SERVICE BULLETIN

N° **139-522**

**ATA 95 - INSTALLATION OF COCKPIT AND CABIN PASSENGER FLOOR BALLISTIC PROTECTIONS**

To provide all necessary instructions on how to perform the installation of the kit cockpit floor ballistic protection P/N 4G9580F00311, kit cockpit door ballistic protection P/N 4G9580F00411 and kit cabin passenger floor ballistic protection P/N 4G9580F00911.

Figure 22

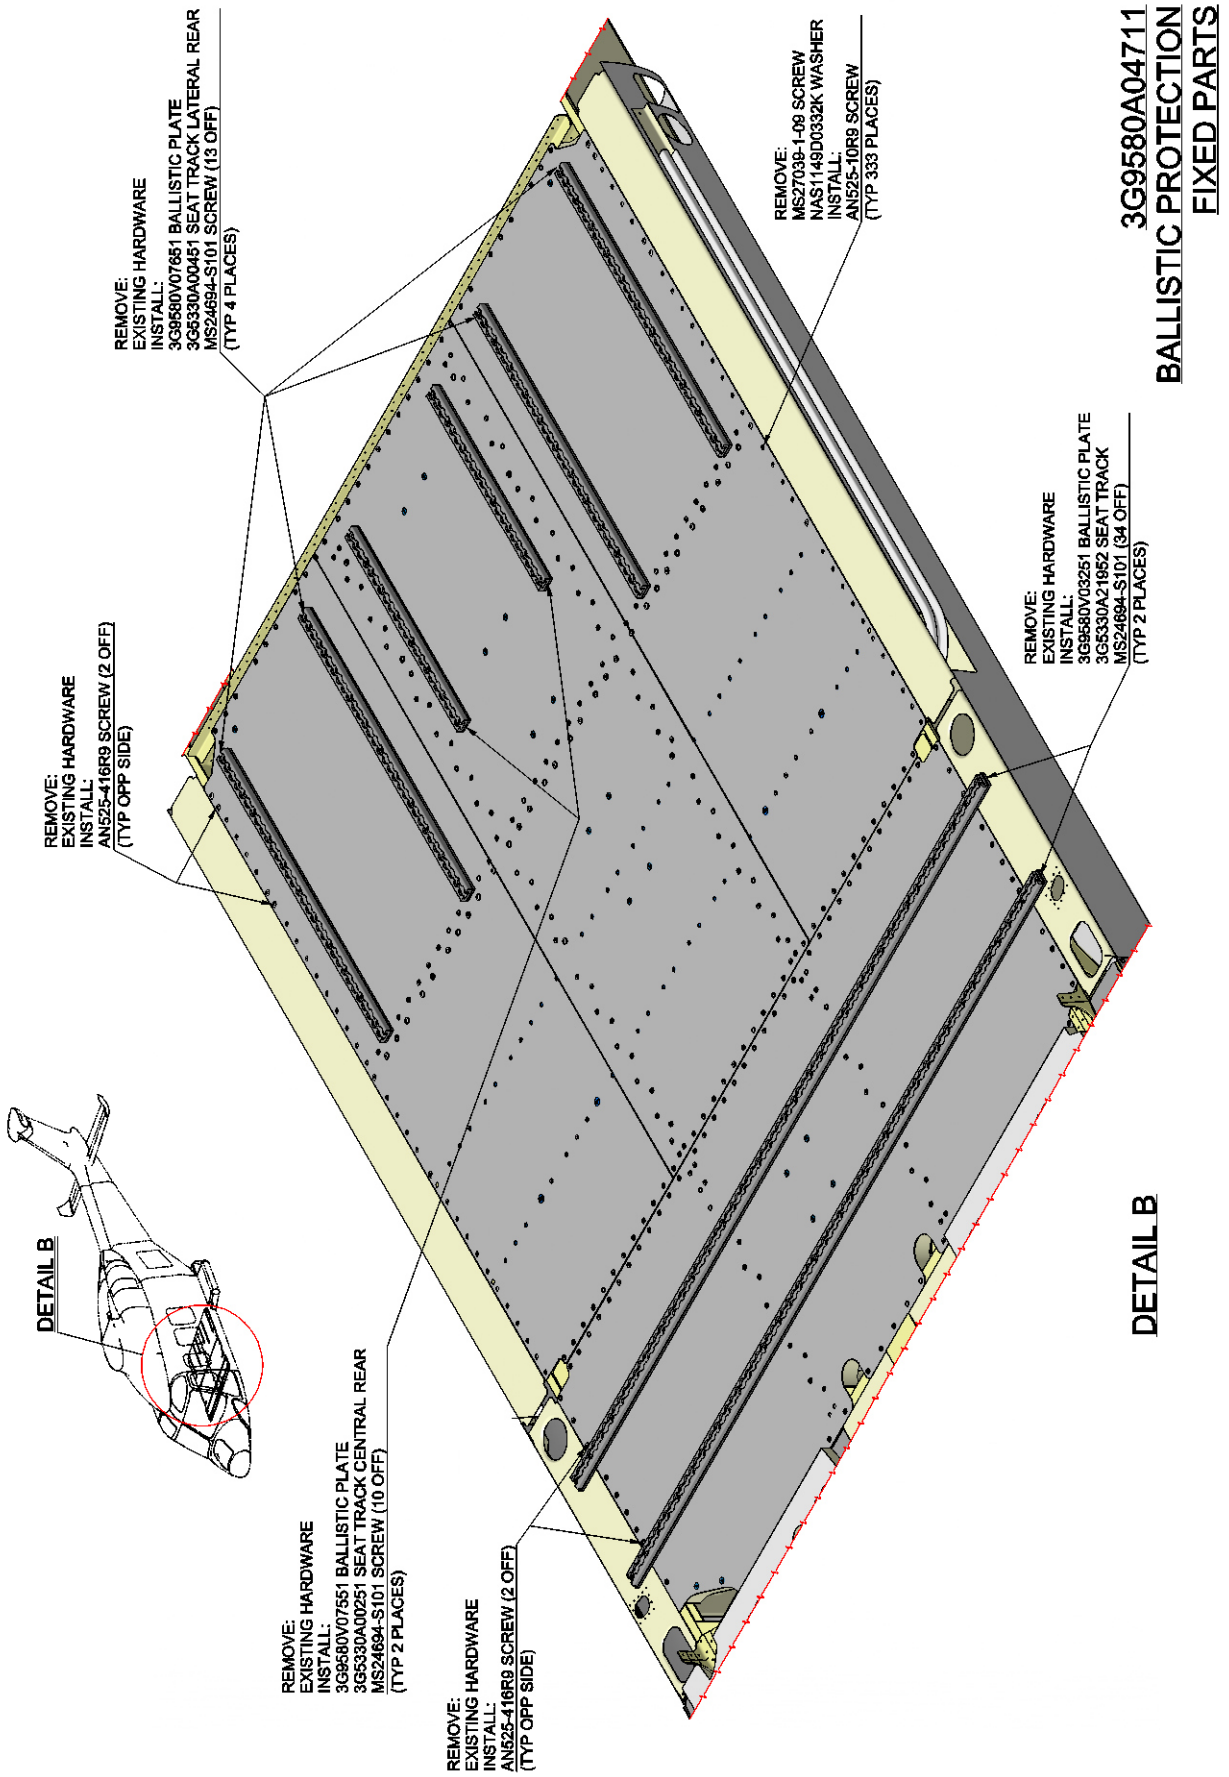
- 3.1 With reference to Figure 22 Detail B, replace the n°333 screws P/N MS27039-1-09 securing the floor panels with n°333 screws P/N AN525-10R9.
  - 3.2 With reference to Figure 22 Detail B, remove the indicated n°2 seat-tracks P/N 3G5330A21952 and relevant hardware; re-install the n°2 seat-tracks and relevant n°2 ballistic plates P/N 3G9580V03251 by means of n°34 screws P/N MS24694-S101.

- 3.3 With reference to Figure 22 Detail B, remove the indicated n°4 seat-tracks P/N 3G5330A00451 and relevant hardware; re-install the n°4 seat-tracks and relevant n°4 ballistic plates P/N 3G9580V07651 by means of n°52 screws P/N MS24694-S101.

- 3.4 With reference to Figure 22 Detail B, remove the indicated n°2 seat-tracks P/N 3G5330A00251 and relevant hardware; re-install the n°2 seat-tracks and

- 3.5 With reference to Figure 22 Detail B, replace the indicated n°8 screws with n°8 screw AN525-416R9.
4. Return the helicopter to flight configuration and record for compliance with Part VI of this Service Bulletin on the helicopter logbook.
5. Gain access to My Communications section on [Leonardo Customer Portal](#) and compile the "Service - Technical Bulletin Application".

Figure 23

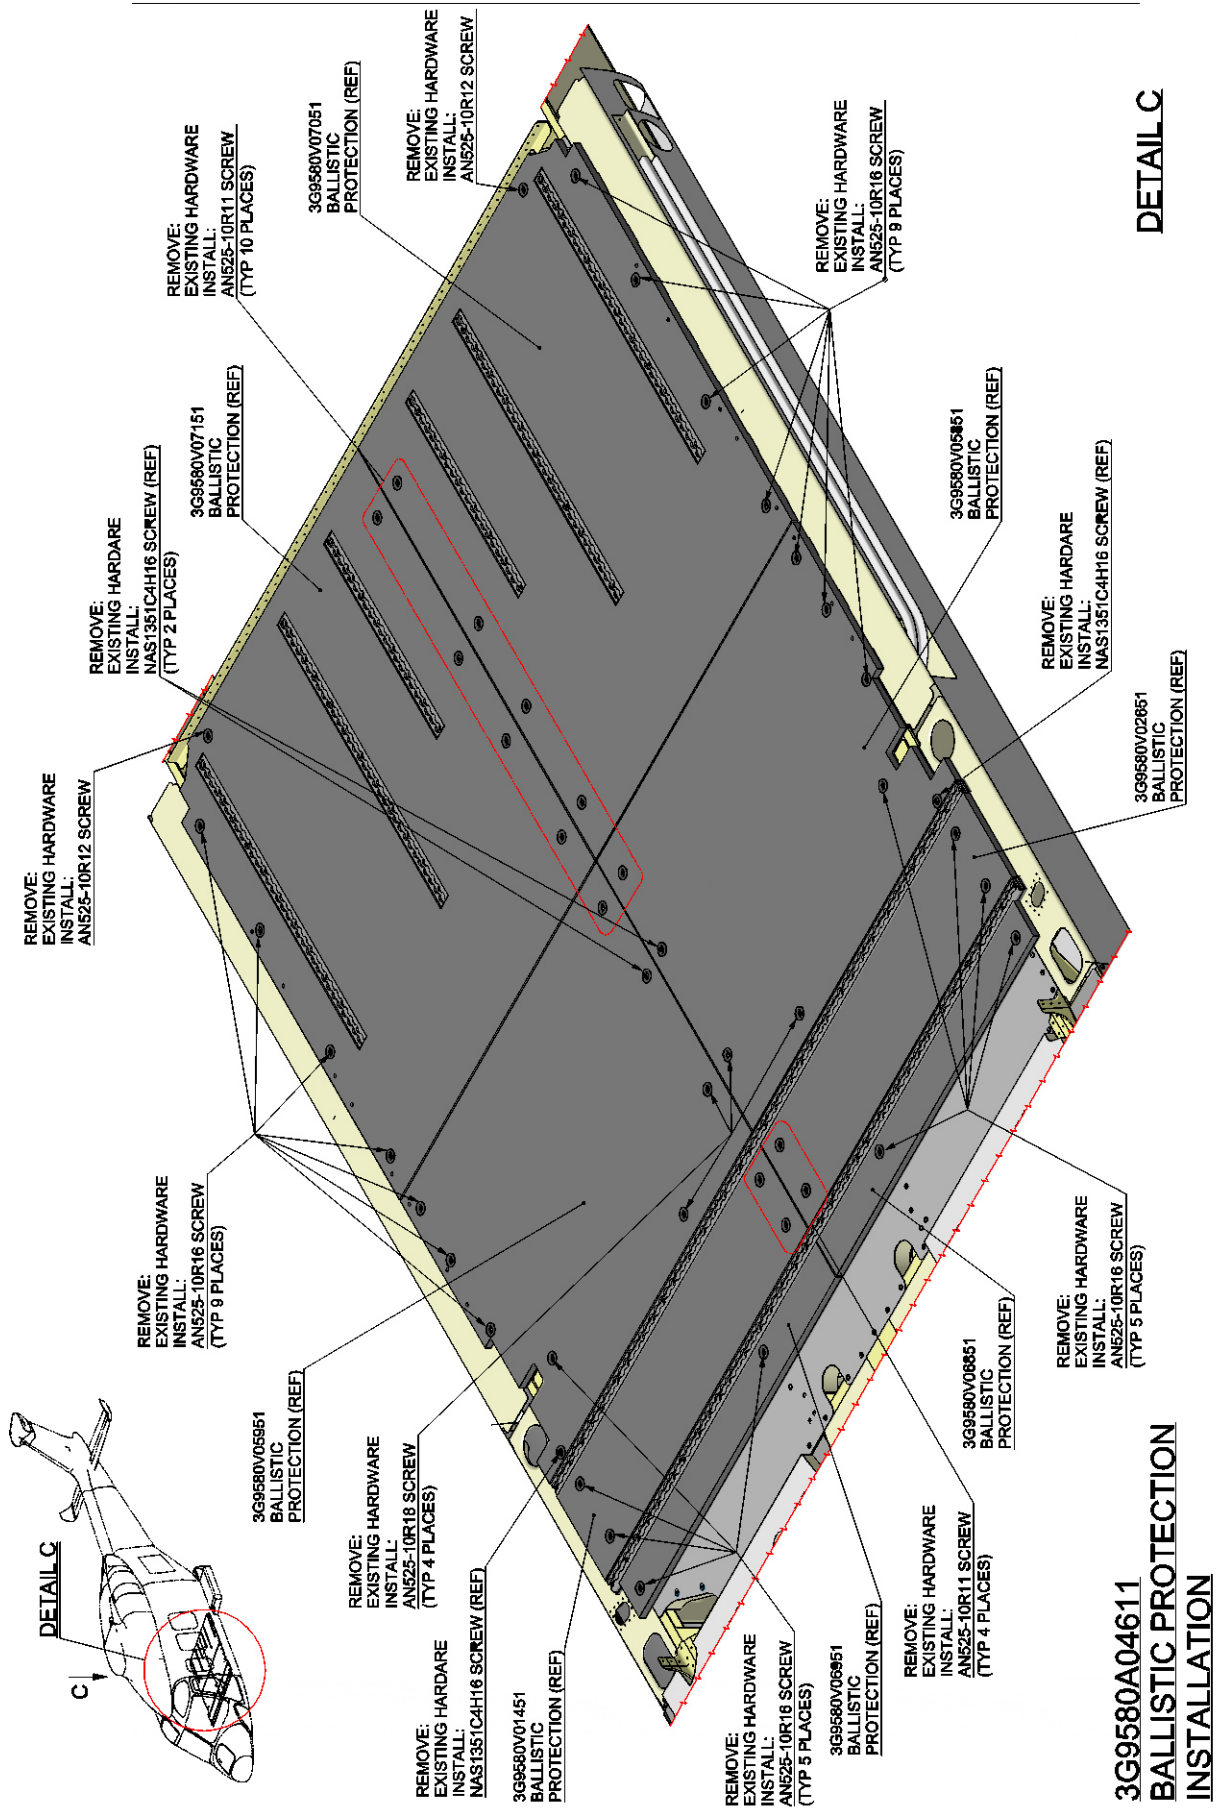
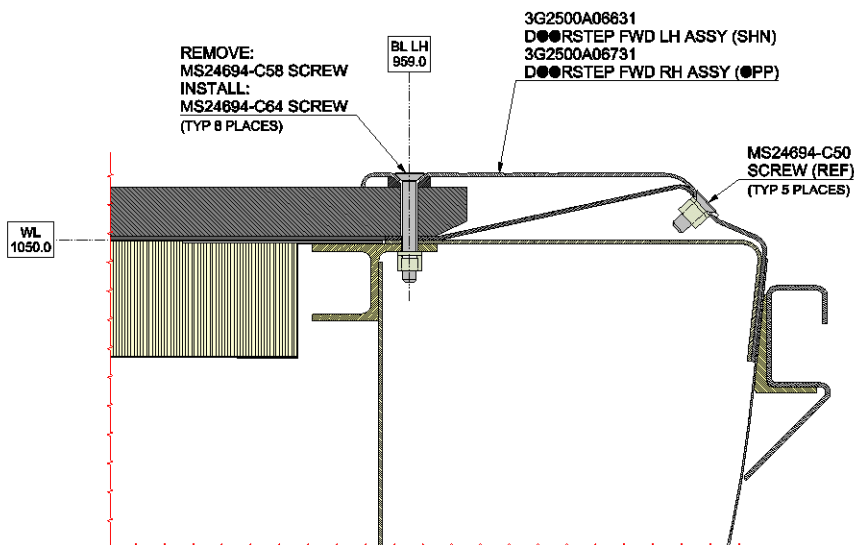
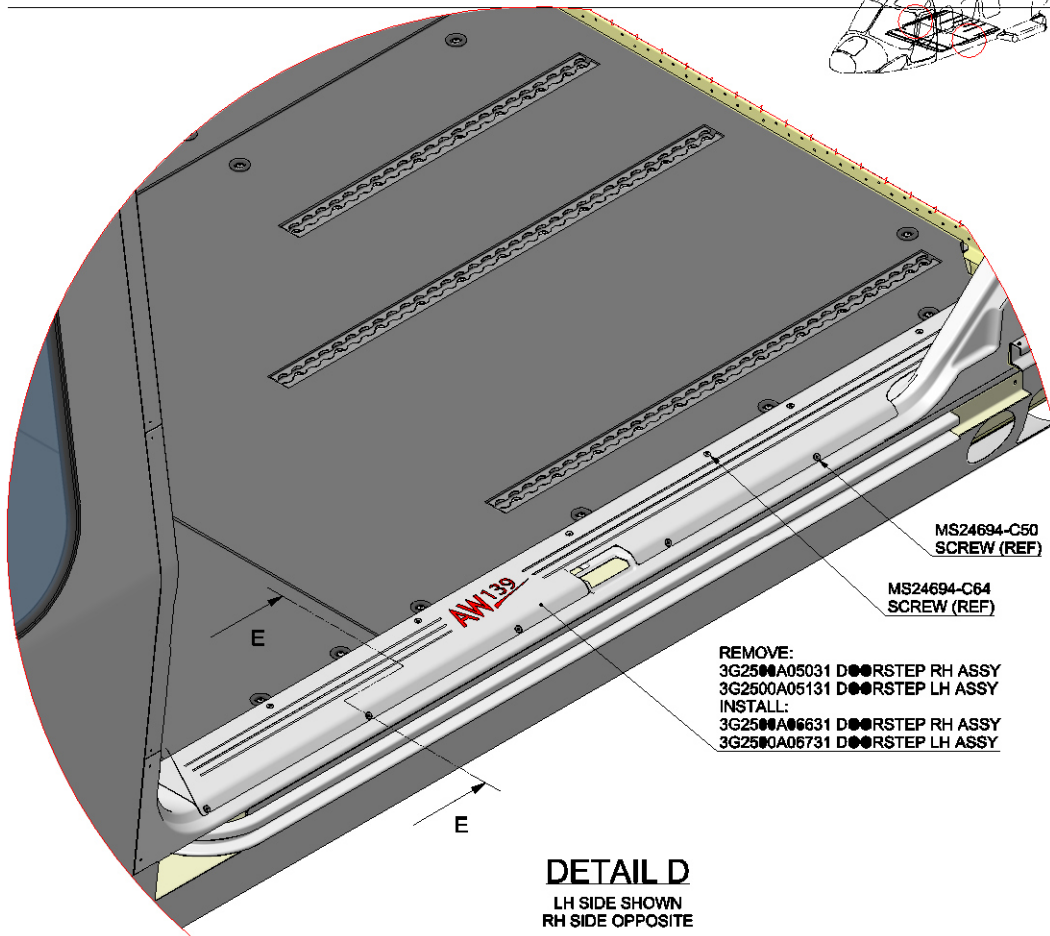
- 2.2 With reference to Figure 24 Detail D, remove the LH doorstep assy P/N 3G2500A05131 from the helicopter.
  - 2.3 With reference to Figure 23 Detail C, remove the existing hardware and install the ballistic protection P/N 3G9580V06951 by means of n°2 screws P/N AN525-10R16.

- 2.4 With reference to Figure 23 Detail C, remove the existing hardware and install the ballistic protection P/N 3G9580V06851 by means of n°2 screws P/N AN525-10R16.

- 2.5 With reference to Figure 23 Detail C, remove the existing hardware and install the ballistic protection P/N 3G9580V01451 by means of n°2 screws P/N AN525-10R16 and n°2 screws P/N AN525-10R11.

- 2.6 With reference to Figure 23 Detail C, remove the existing hardware and install the ballistic protection P/N 3G9580V02651 by means of n°2 screws P/N AN525-10R16 and n°2 screws P/N AN525-10R11.

- 2.7 With reference to Figure 23 Detail C, remove the existing hardware and install the ballistic protection P/N 3G9580V05951 by means of n°4 screws P/N AN525-10R16, n°2 screws P/N AN525-10R18 and n°2 screws P/N NAS1351C4H16.

- 2.8 With reference to Figure 23 Detail C, remove the existing hardware and install the ballistic protection P/N 3G9580V05851 by means of n°4 screws P/N AN525-10R16, n°2 screws P/N AN525-10R18 and n°2 screws P/N NAS1351C4H16.

- 2.9 With reference to Figure 23 Detail C, remove the existing hardware and install the ballistic protection P/N 3G9580V07151 by means of n°4 screws P/N AN525-10R16, a screw P/N AN525-10R12 and n°4 screws P/N AN525-10R11.

- 2.10 With reference to Figure 23 Detail C, remove the existing hardware and install the ballistic protection P/N 3G9580V07051 by means of n°4 screws P/N AN525-10R16, a screw P/N AN525-10R12 and n°4 screws

**Figure 24**

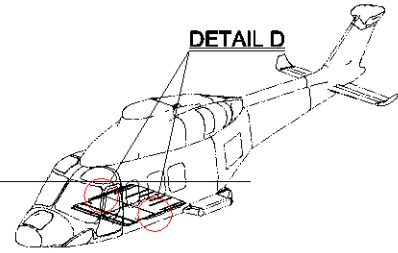
2. Perform the ballistic protection installation P/N 3G9580A04611 as described in the following procedure:
  - 2.1 With reference to Figure 24 Detail D, remove the RH doorstep assy P/N 3G2500A05031 from the helicopter.

- 2.11 With reference to Figure 24 Detail D and section E-E, install the LH doorstep assy P/N 3G2500A06731 by means of n°3 screws P/N MS24694-C64 and n°2 existing screws P/N MS24694-C50.
- 2.12 With reference to Figure 24 Detail D and section E-E, install the FWD RH doorstep assy P/N 3G2500A06631 by means of n°6 screws P/N MS24694-C64 and n°5 existing screws P/N MS24694-C50.
3. Return the helicopter to flight configuration and record for compliance with Part VII of this Service Bulletin on the helicopter logbook.
4. Gain access to My Communications section on [Leonardo Customer Portal](#) and compile the “Service - Technical Bulletin Application”.

Figure A2

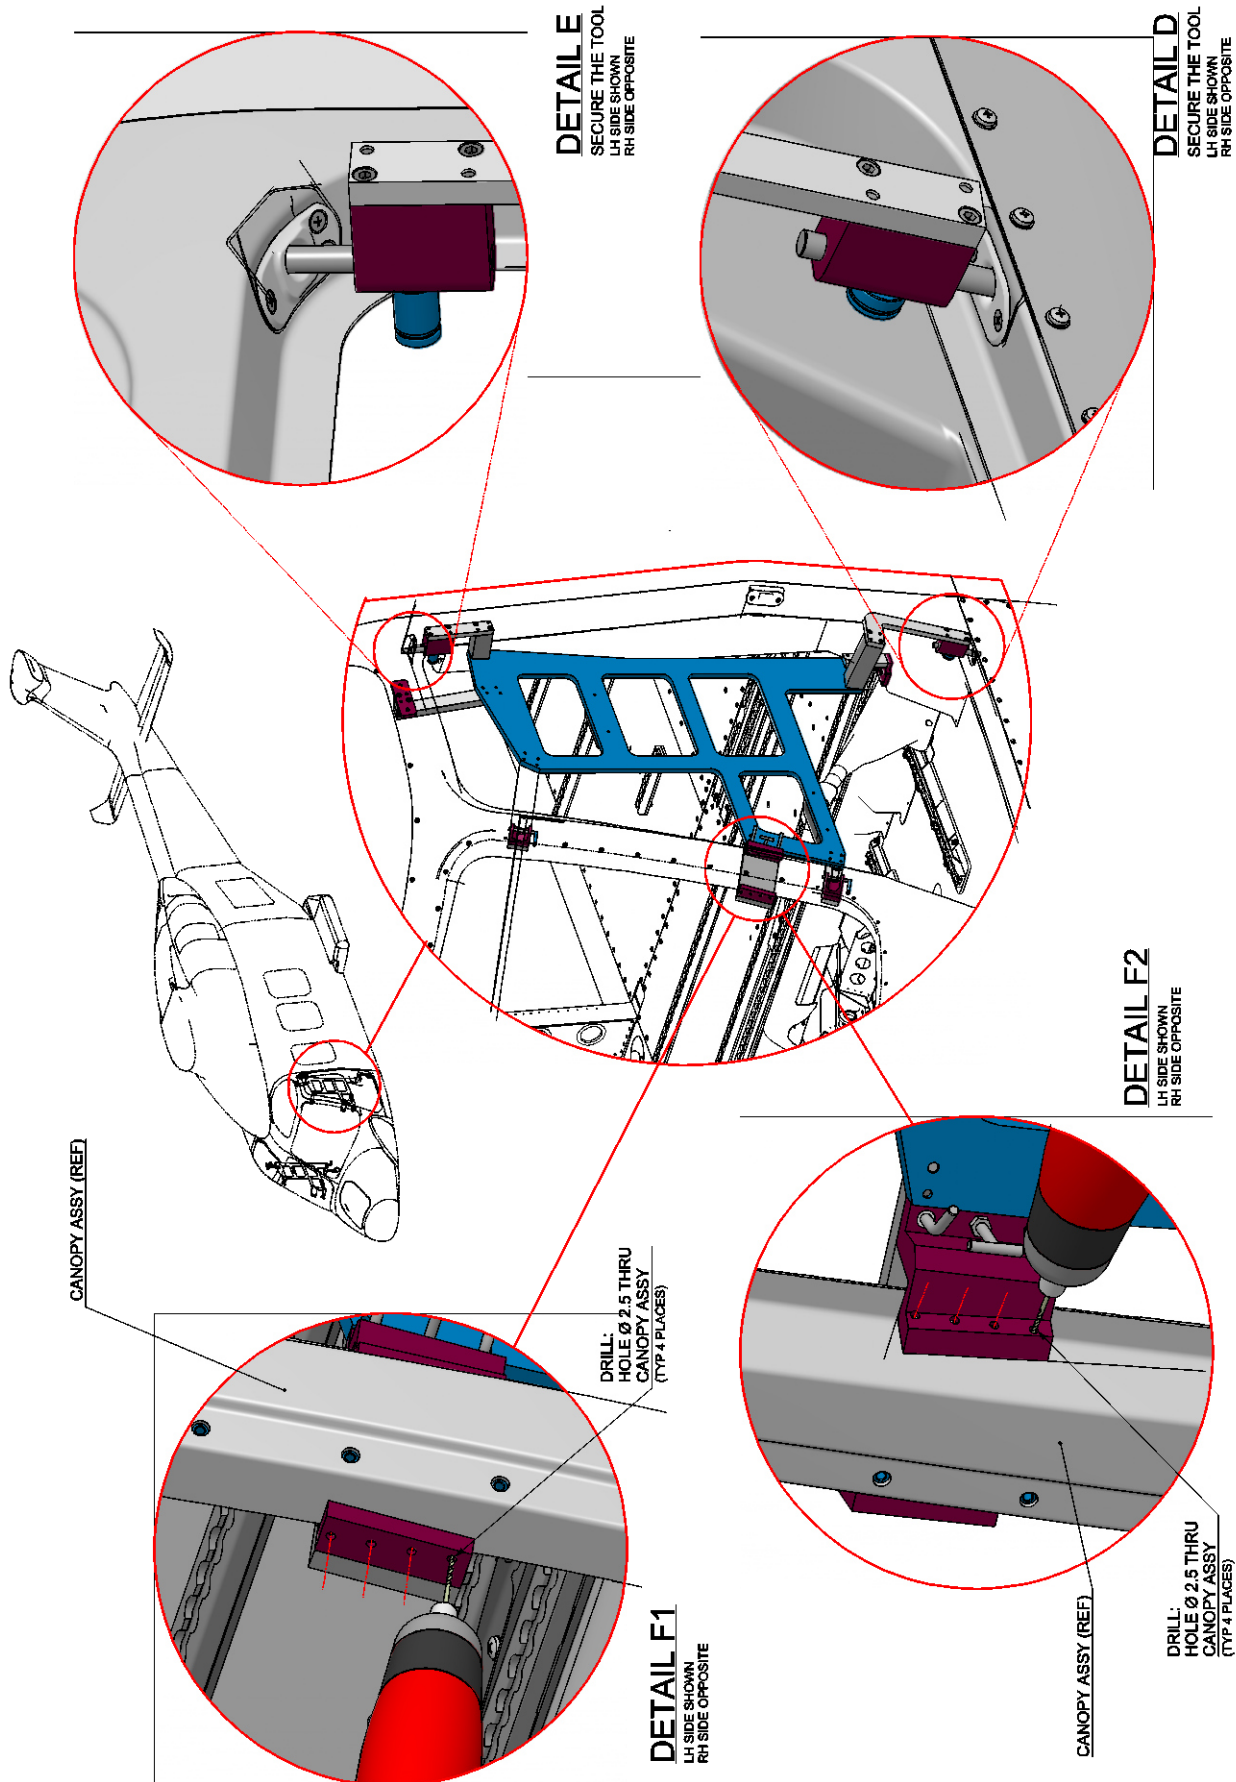
3. With reference to Figure A2 Details D and E lock the drilling tool P/N 3G5310H68511A003A LH to the upper and lower door provisions by means of tool hardware.

4. With reference to Figure A2 Detail F1 drill n°4 holes Ø2.5 thru canopy assy by means of drilling gig guide holes.
5. With reference to Figure A2 Detail F2 drill n°4 holes Ø2.5 thru canopy assy by means of drilling gig guide holes.

14. With reference to Figure A2 Detail F1 drill n°4 holes Ø2.5 thru canopy assy by means of drilling gig guide holes.
15. With reference to Figure A2 Detail F2 drill n°4 holes Ø2.5 thru canopy assy by means of drilling gig guide holes.
